## ADDENDUM NO. 3

Project Name: Landfill Household Hazardous Waste and Recycling Transfer Facility

Bid Number: 2022011

**REPLACE Sheets S-200, S-300, S-301, S-400** with Revised Sheets (A set of revised structural sheets with callouts indicating the change, and a set of full structural plans are provided)

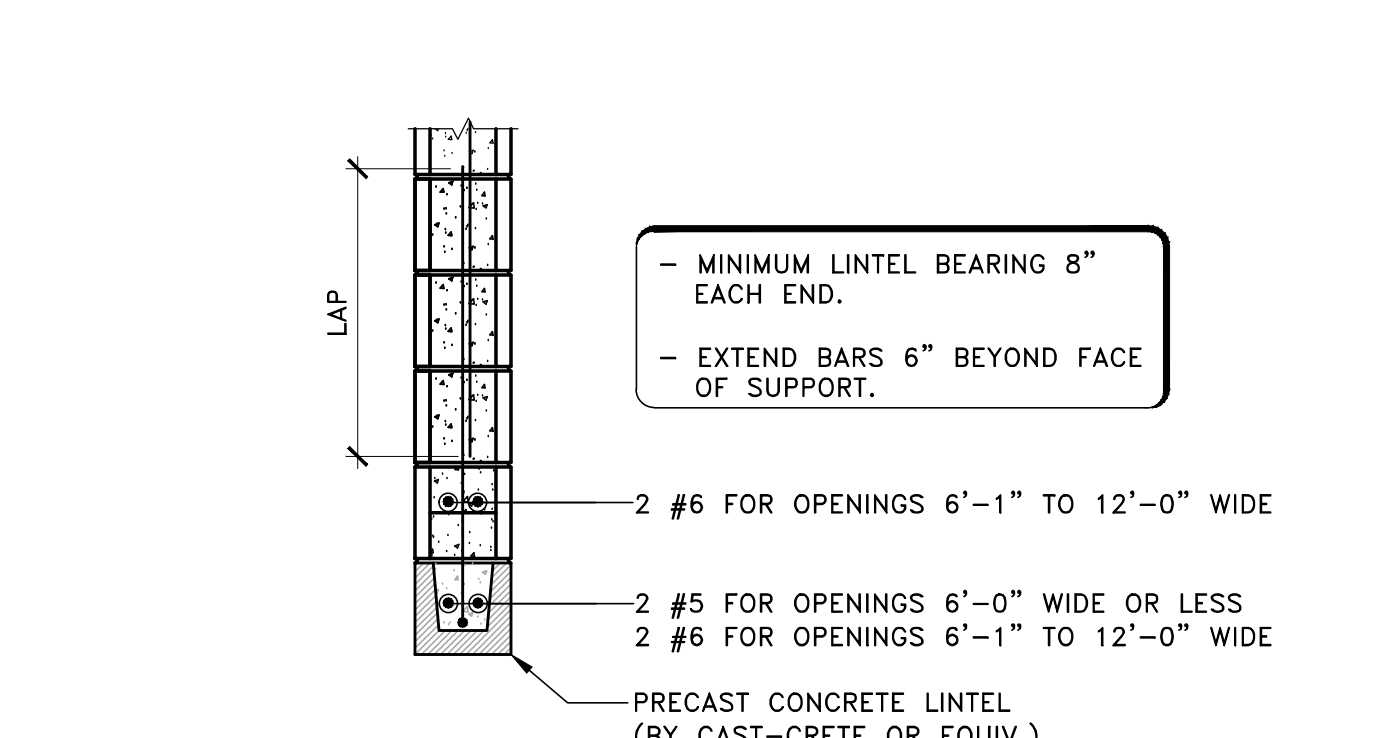
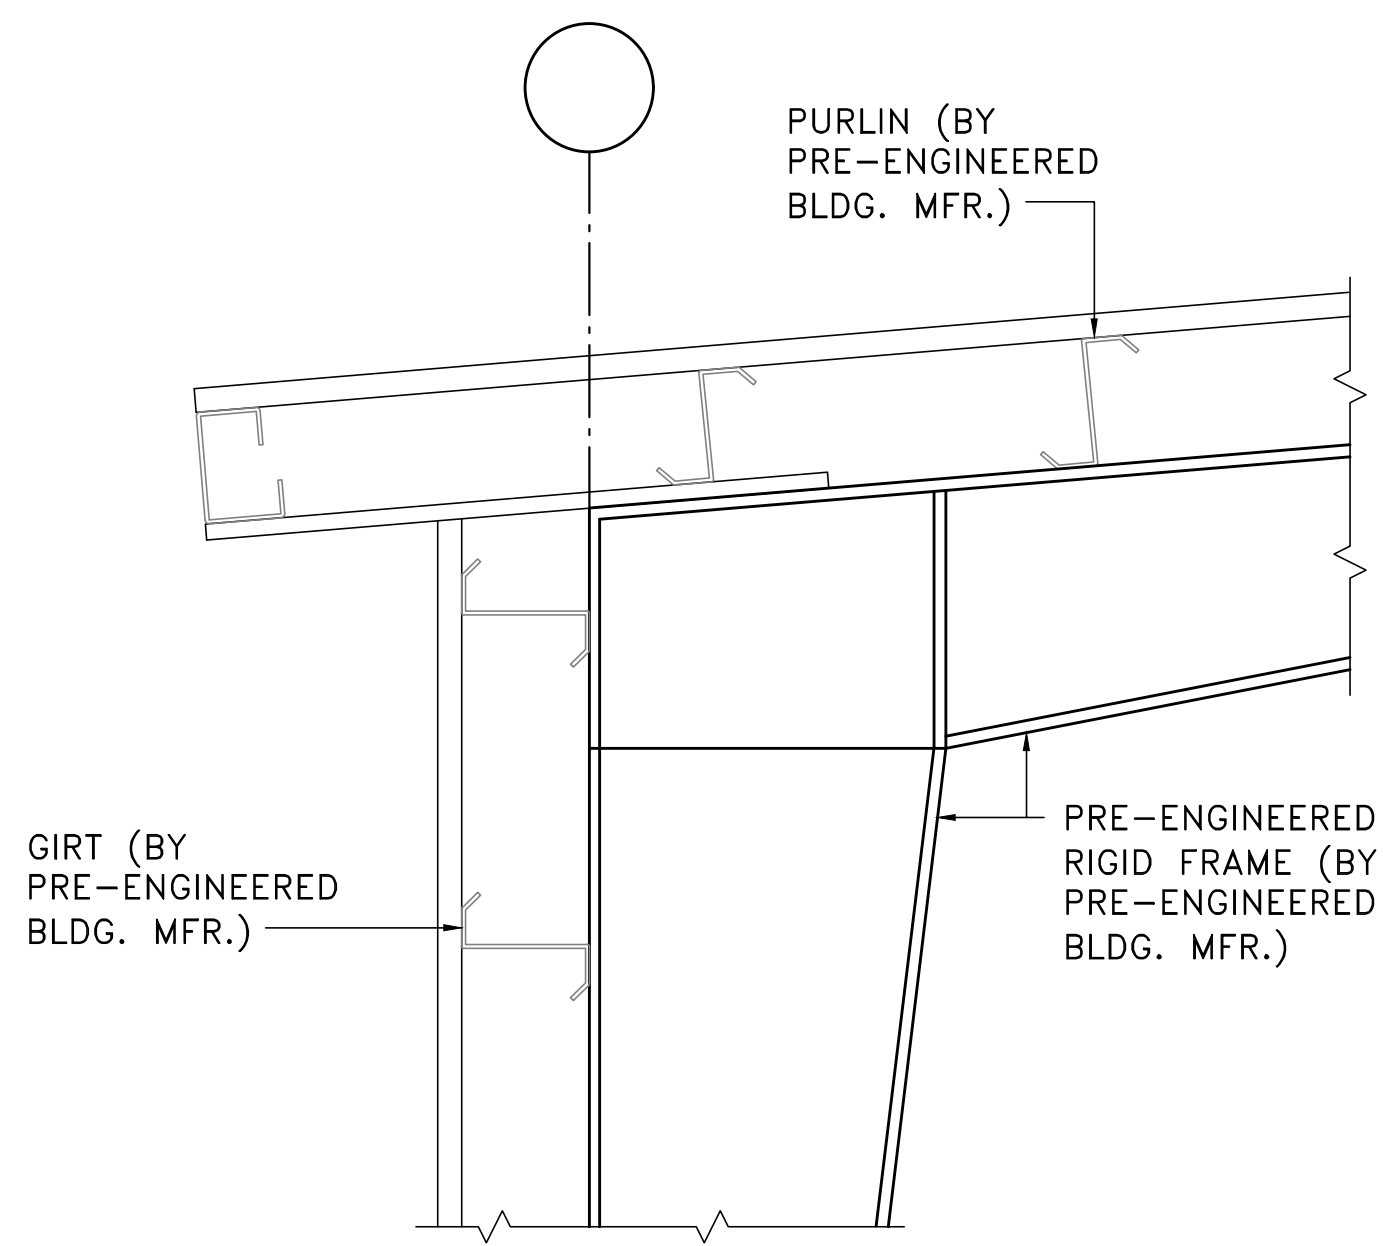
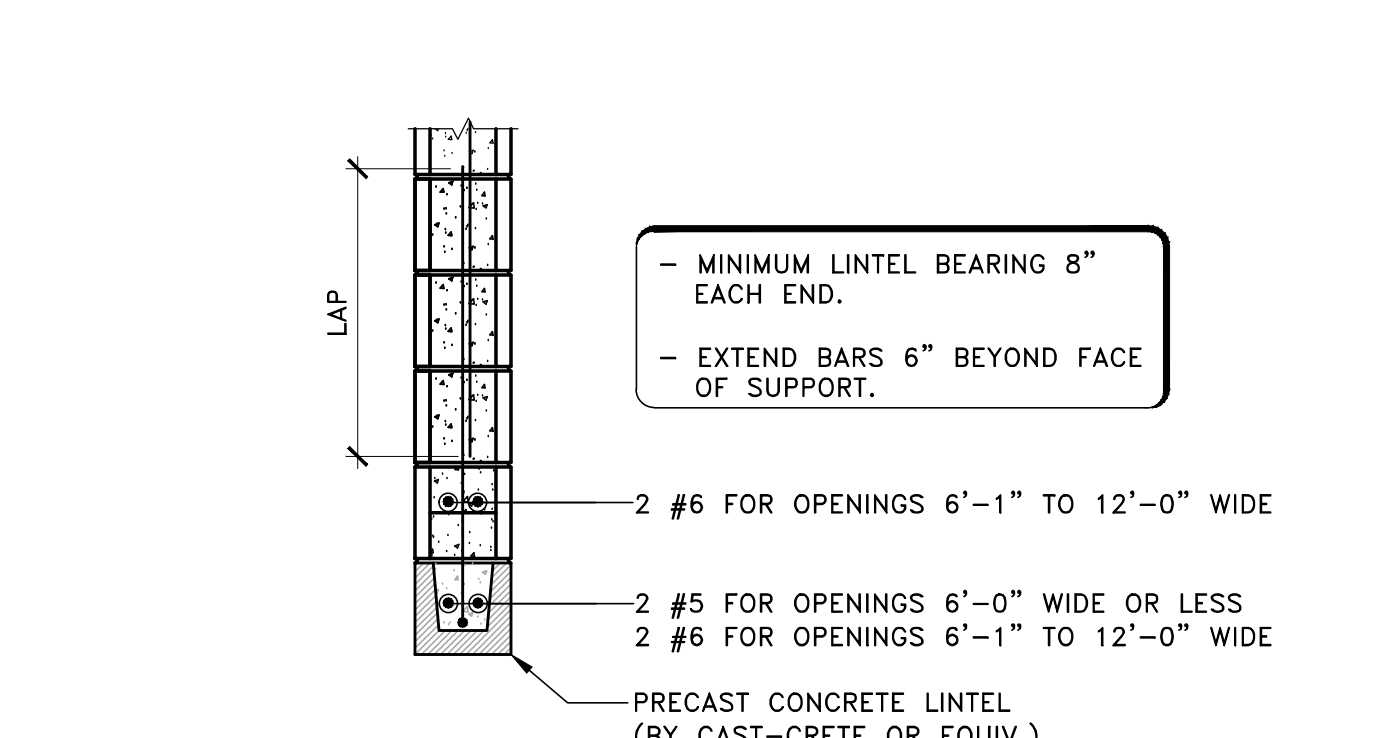
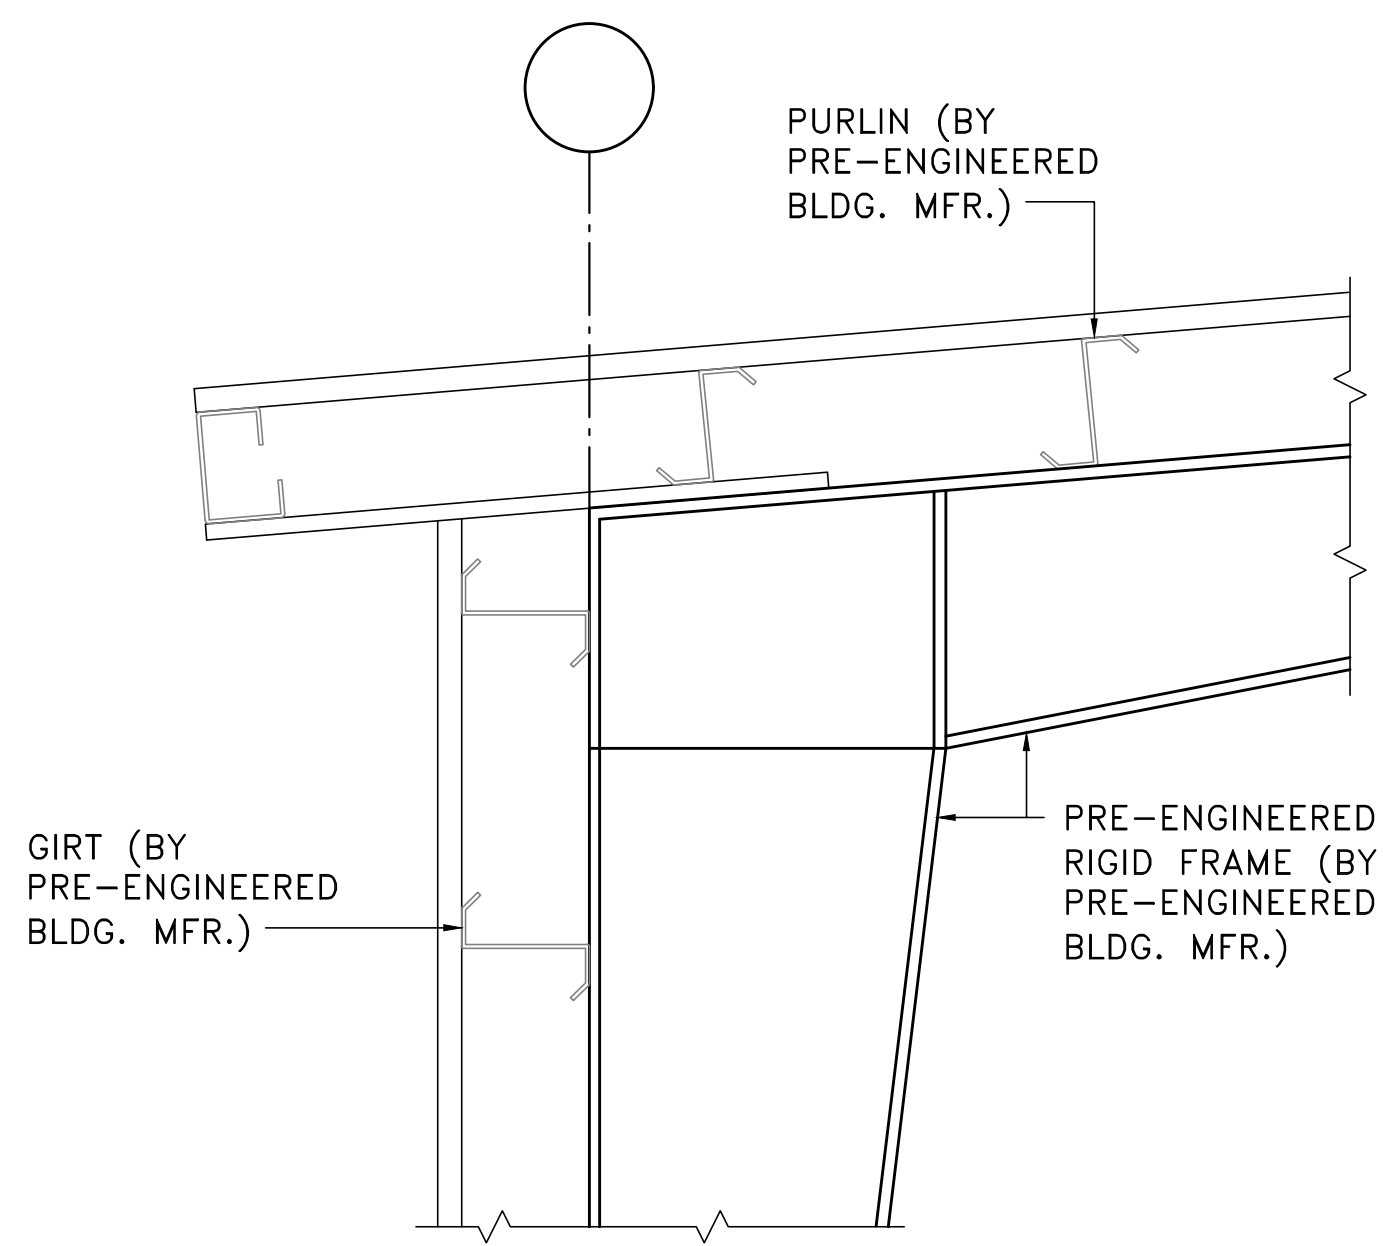
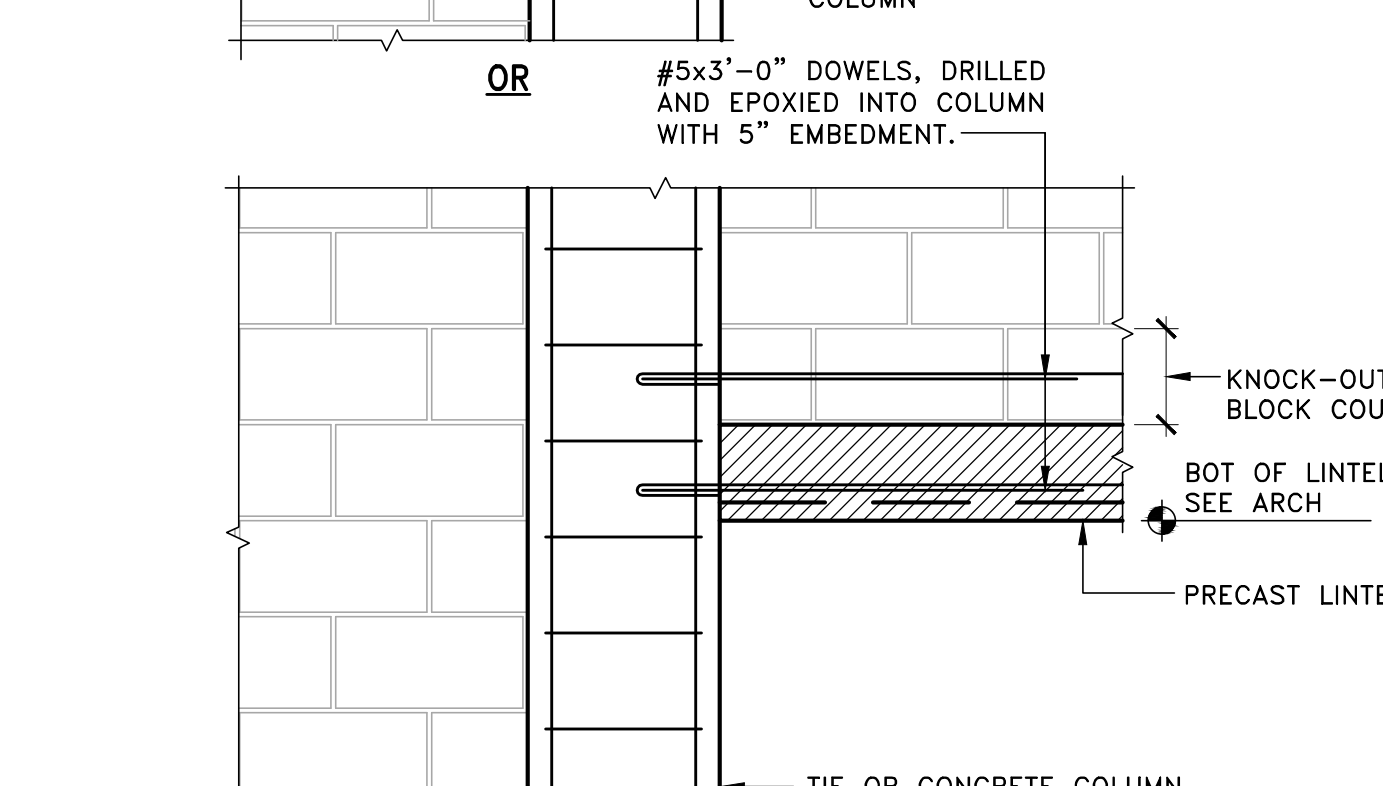
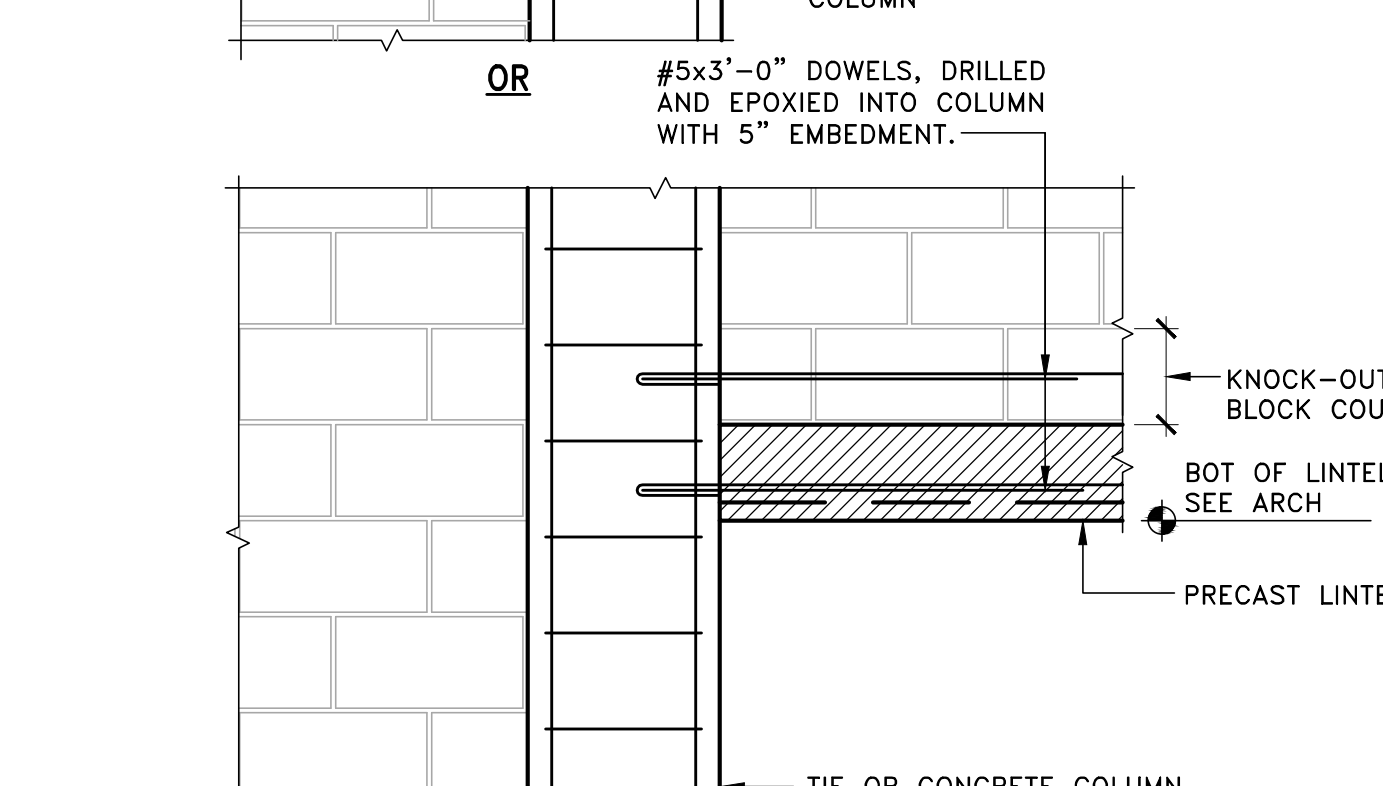
**Refer to revised detail 6/S-400.**
8. Sheet S-201 shows at line B a detail 7/S-400; line D a detail 8/S-400, and at line E a detail 9/S-400 but when you go to S-400 there is no detail 7, 8, or 9.

**Refer to revised sheet S-400.**
9. Sheet A103 shows line A going from 1 to 5; sheet S200 and S201 shows line A only going from 1 to 3. Please advise.

6 PRECAST LINTEL AT COL.  
SCALE: 3/4"=1'-0"

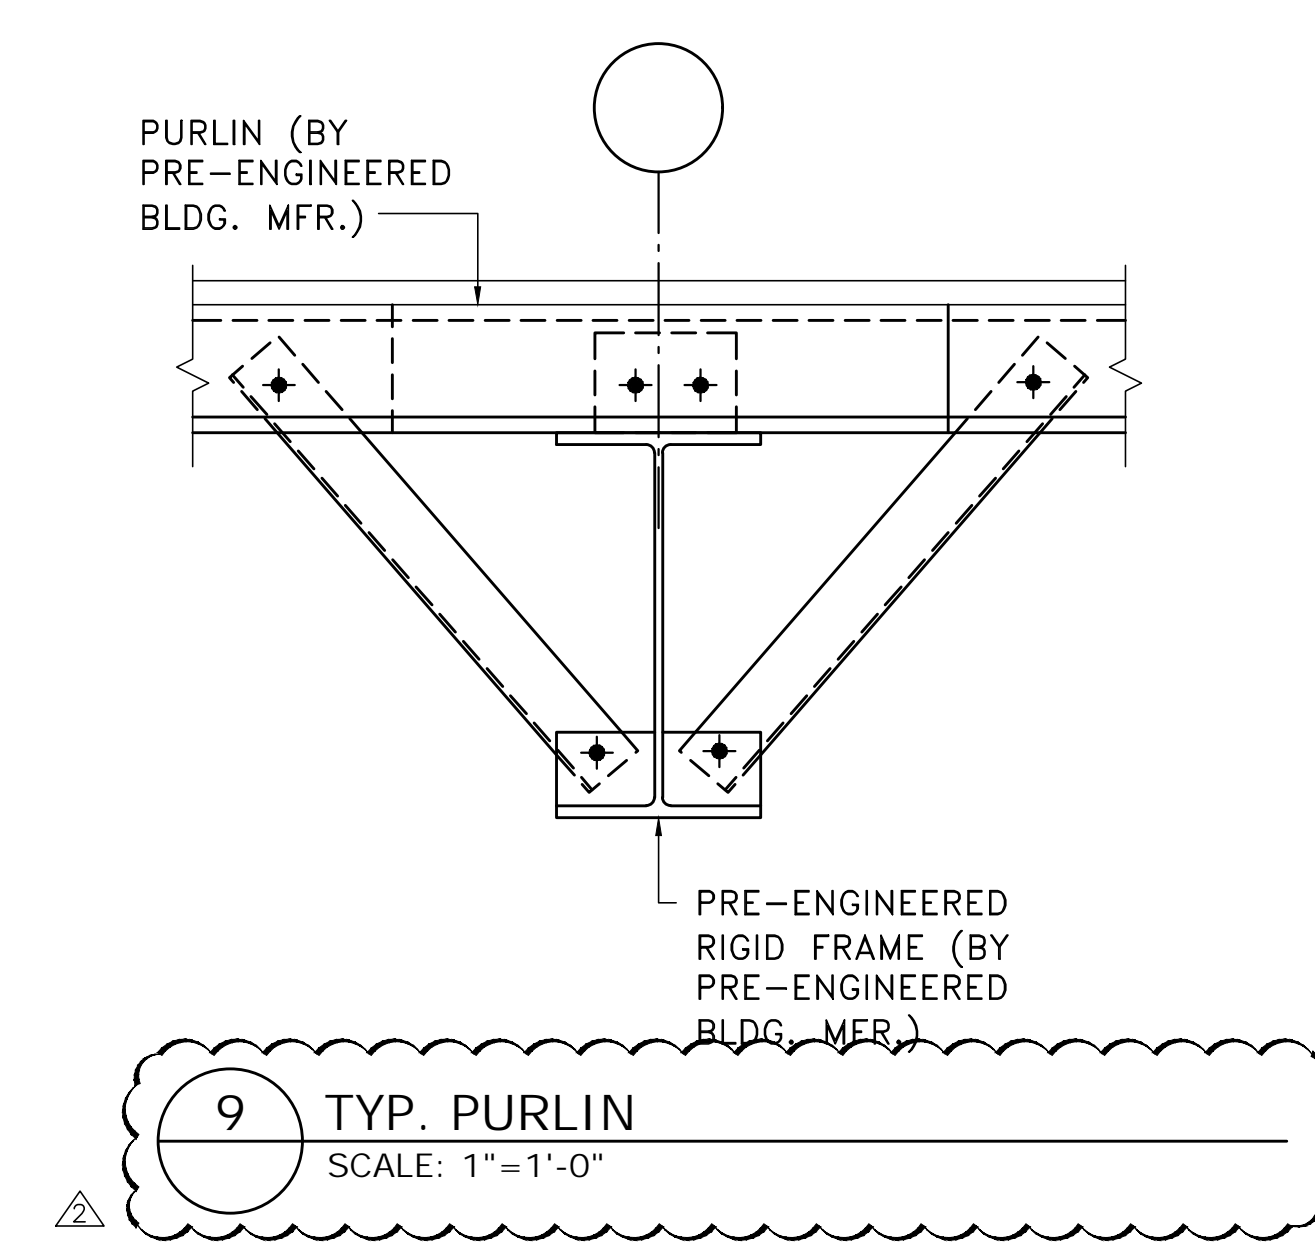
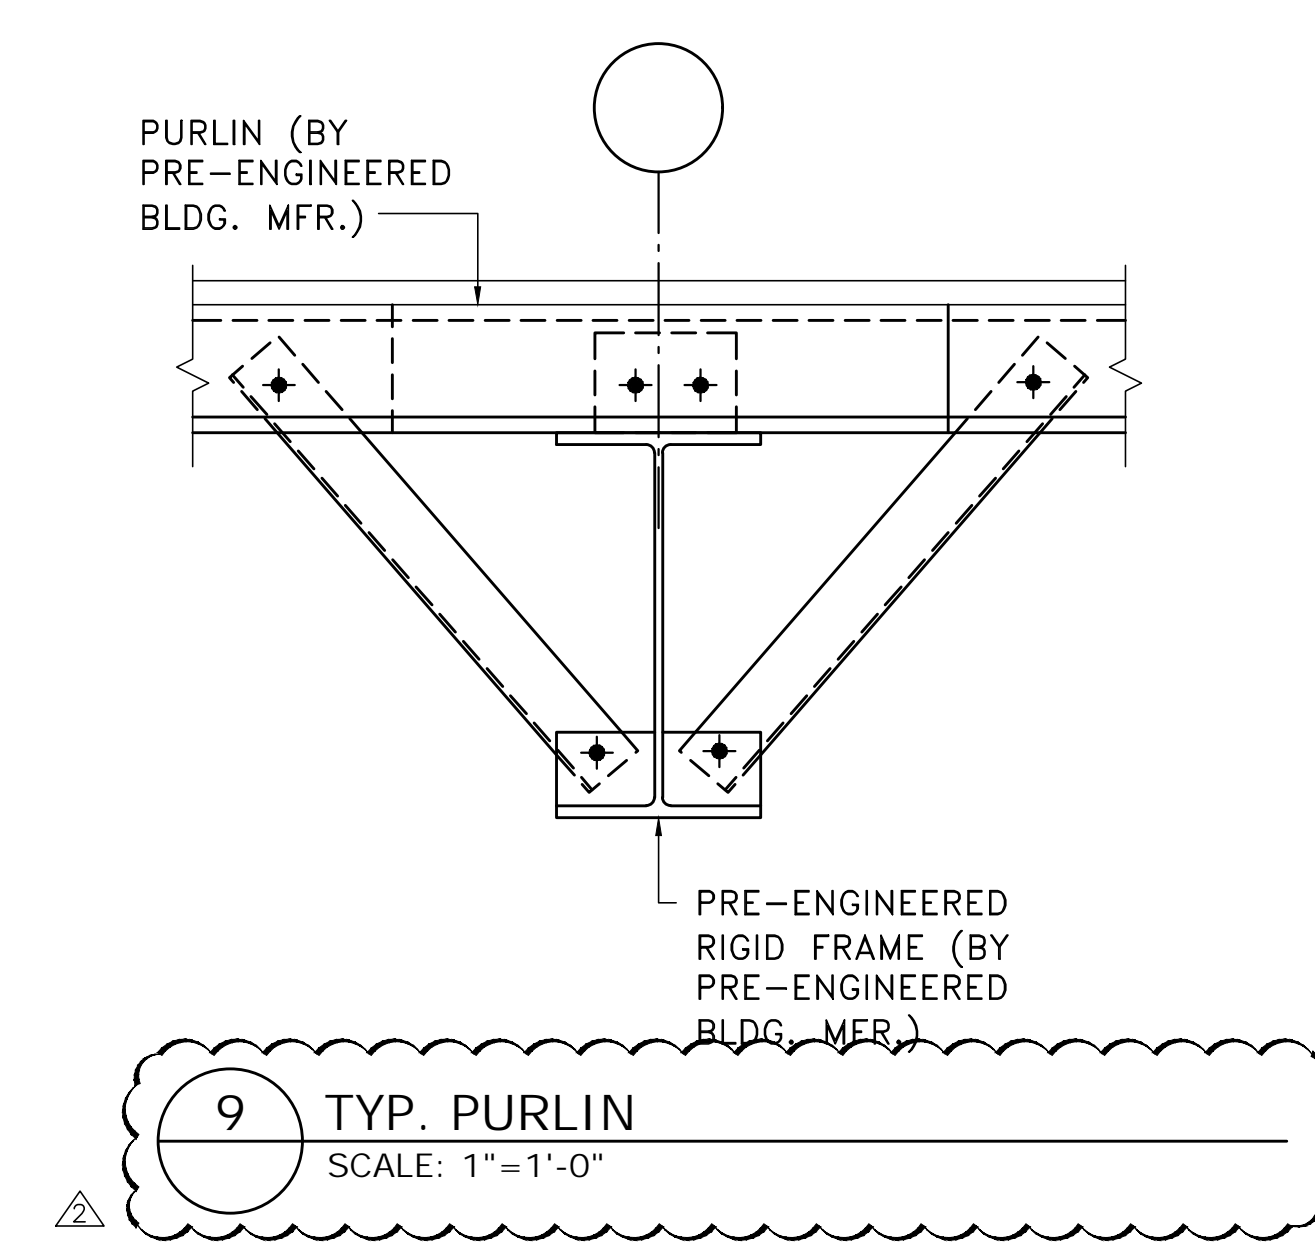
7. Sheet S-400 detail 6 shows the top of wall at line C getting a heavy angle attached to the wall and then our roof screwing off to it. We cannot do it this way, the roof cannot take this load, we will need to supply masonry support beams at top of the wall that goes from column to column that is designed for L/240 for the wall to attach too. Please advise.
